Project Name : Land at Stakers Farm, Yapton
Job No : 19-156
Note Title : Highways Technical Note
Author : ESH
Checked : SRD
Approved : SCW
Date : January 2020

LAND AT STAKERS FARM, YAPTON
DESIGNERS RESPONSE TO ROAD SAFETY AUDIT STAGE 2 – SECTION 278 WORKS

Drawing Title
S278 GENERAL ARRANGEMENT AND CONSTRUCTION MAKEUP

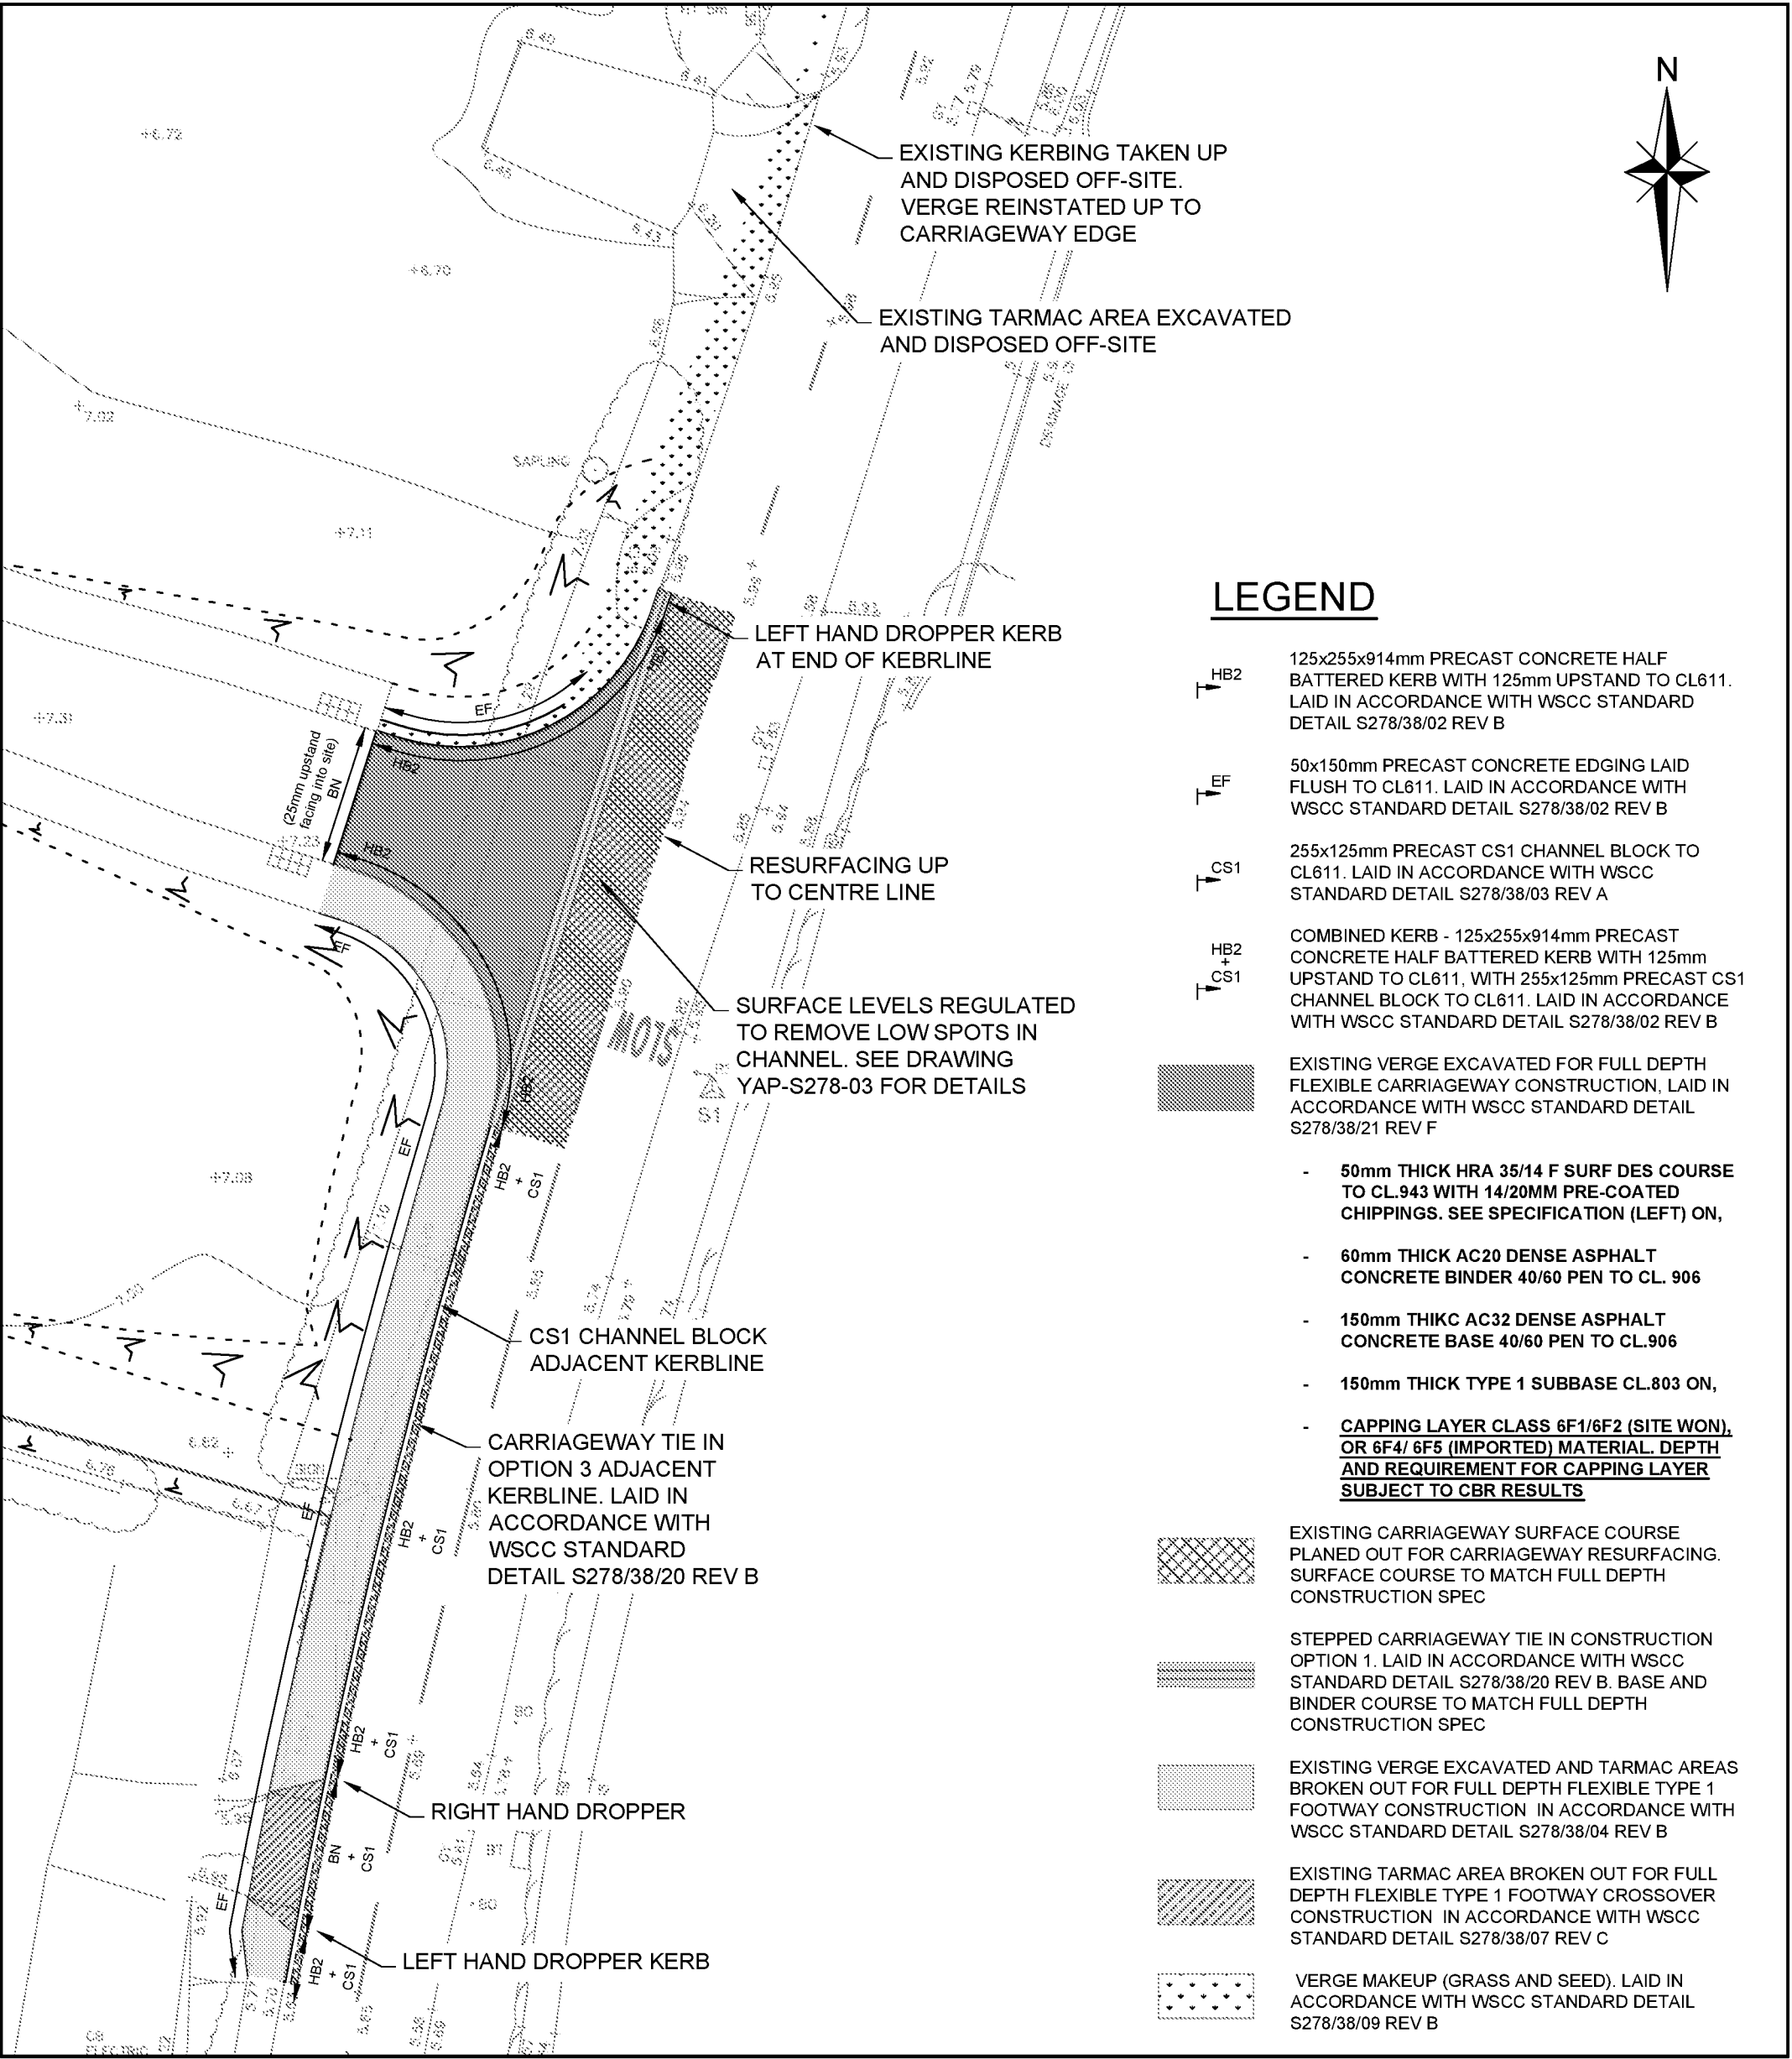
Audit Item No.	Audit Team Observation	Audit Team Recommendation	Odyssey Designer's Response	Client Comment
3.1	Location: East side of B2132. Summary: Potential for standing water and localised flooding. The proposed access road is to be provided on a gradient. There is a concern that surface water run-off will collect on the east side of the B2132 carriageway opposite the site in an area where the verge is in a poor and muddy condition from over-running. There is a risk that inadequate drainage may lead to ponding in this location and loss of-control or skid-type incidents resulting in collisions, particularly involving powered two wheelers, and possible injuries to occupants or riders.	It is recommended that suitable highway drainage is provided.	Background: The existing ponding issues on the eastern side of North End Road are a result of vehicle overrun and existing highway trafficking. The proposed Section 278 works do not interfere with this area, nor do they contribute/increase the existing overrun issues in this area. Design: Drawing ref YAP-S278-04 has since been provided demonstrating drainage as part of the S278 works. Whilst the bellmouth access will create additional surface water run-off, additional gullies will be placed on the western side of North End Road and in combination with the camber on North End Road itself, this will ensure additional surface water is captured in the western channel and will not exacerbate the current ponding issues on the eastern side of North End Road. As part of the Section 278 proposals, no changes are to be proposed on the eastern verge area and as such this remains a West Sussex County Council Highway Maintenance issue.
